D3849-041 FWD WEARPLATE ASSY, STD GEAR

D3849-043 AFT WEARPLATE ASSY, STD GEAR

D3849-045 AFT WEARPLATE ASSY, FLOAT GEAR

D3849-047 FWD WEARPLATE ASSY, FLOAT GEAR

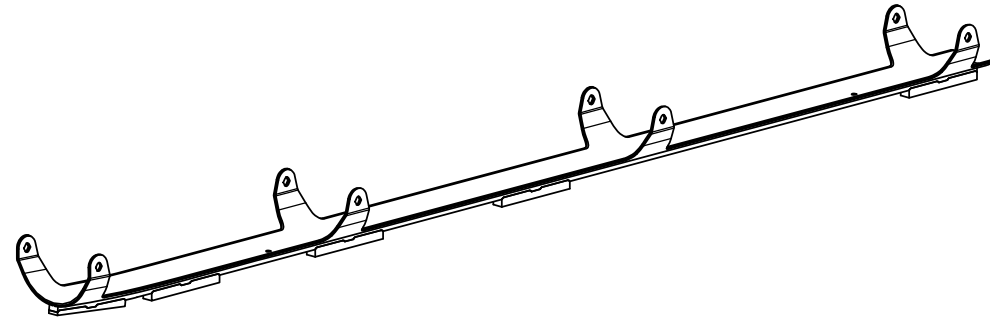
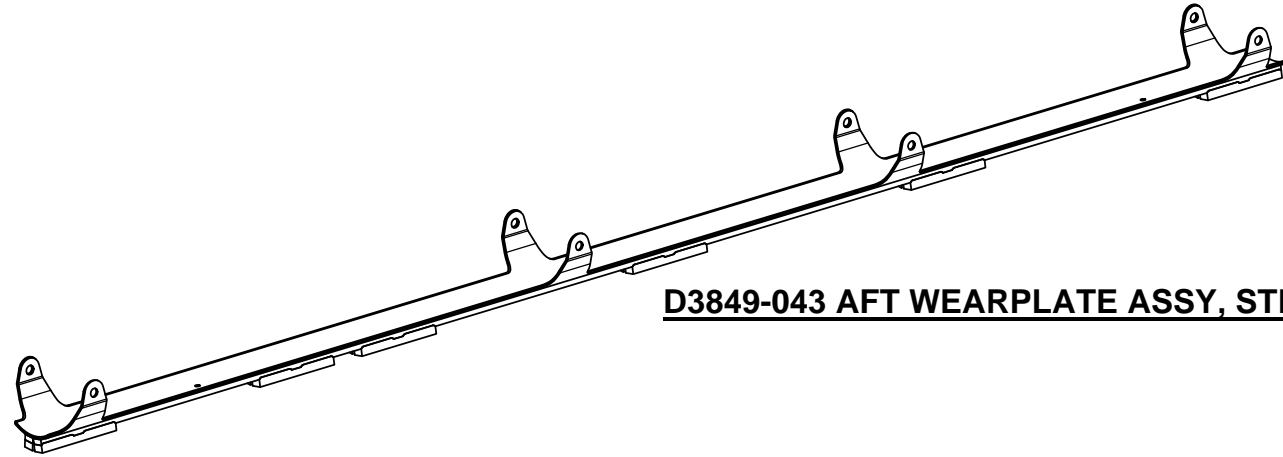
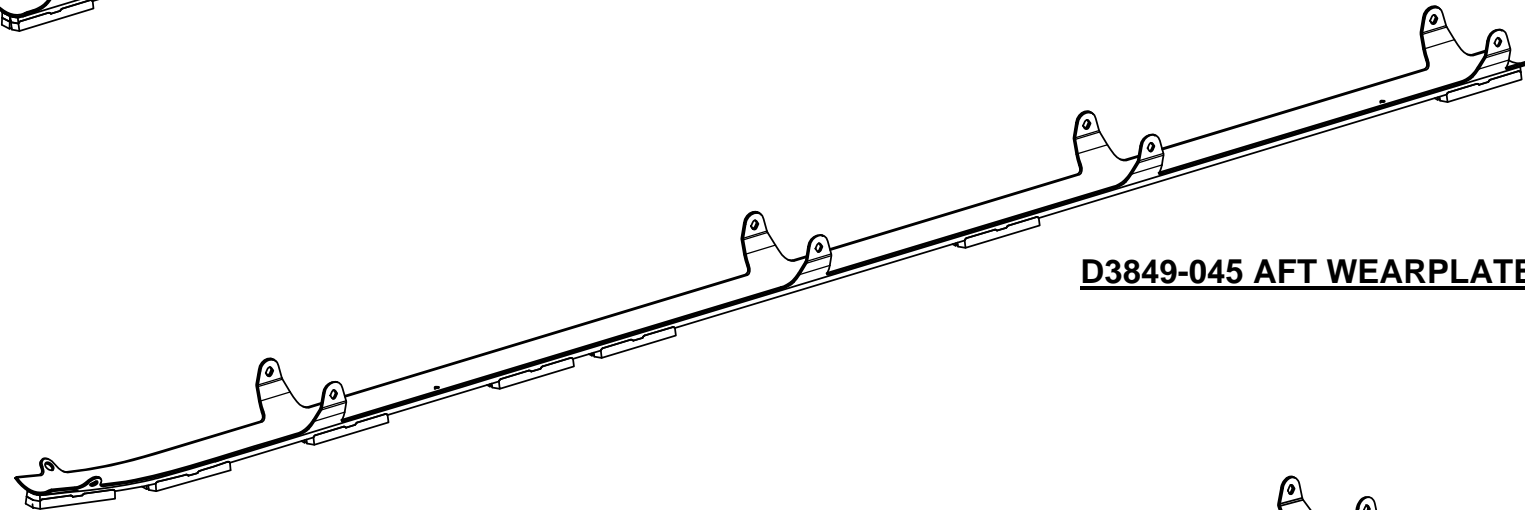
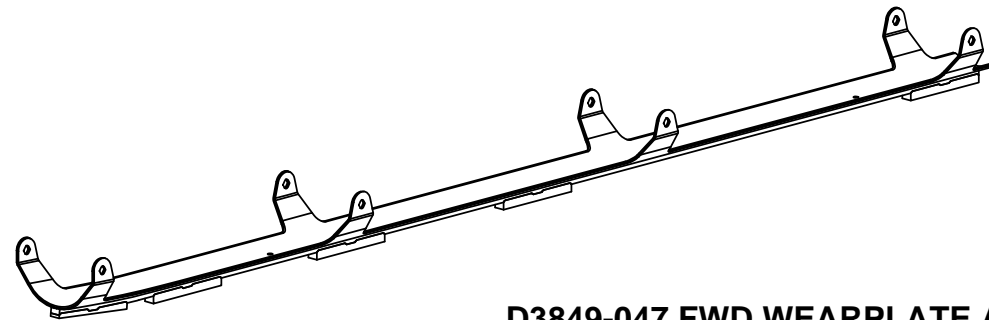
PC4	REVISED FLAT PATTERN - CHANGE SLOT LOCATIONS. ADDED DOUBLE SLOTS ON -.043/-045. UPDATED DETAIL VIEWS. CHANGED WELD DETAILS (ZN B2-2).	DC	12.02.21
B	REVISED FLAT PATTERN Ø 0.375 WAS SLOT HOLE ON D3849-1F/-3F/-5F (ZN A4-5, B4-7, B4-8, C2-10, B2-10); ADD D3849-047 (ZN D4-1, A4-1 & B4-5) & D3849-7/-7F (ZN C4-9, A4-9); ADD SECTION K-K (ZN C5-10); 0.88 WAS 0.875 & 0.44 WAS 0.438 (ZN A3-10); ADD 0.25 & 0.88 (ZN D4-10, D3-10); ADD 0.88 & 0.44 (ZN C3-10 & B3-10); ADD FLAG NOTE (ZN A8-2, C6-2, C3-2, A8-3, C6-3, C3-3, A8-4, C6-4, C2-4); 66.87 WAS 67.36 (ZN B4-7)	RF	09.06.30
A	NEW ISSUE	RF	09.03.30
REV.	DESCRIPTION	BY	DATE
DESIGN	RF	DART AEROSPACE USA, INC. KENT, WA	
DRAWN	<i>SC</i>		
CHECKED		DRAWING NO.	REV. PC4
MFG. APPR.		D3849	SHEET 1 OF 10
APPROVED		TITLE	SCALE
DE APPR.		WEARPLATE ASSY	NTS
DATE	12.08.21	COPYRIGHT © 2009 BY DART AEROSPACE USA, INC. THIS DOCUMENT IS PRIVATE AND CONFIDENTIAL AND IS SUPPLIED ON THE EXPRESS CONDITION THAT IT IS NOT TO BE USED FOR ANY PURPOSE OR COPIED OR COMMUNICATED TO ANY OTHER PERSON WITHOUT WRITTEN PERMISSION FROM DART AEROSPACE USA, INC.
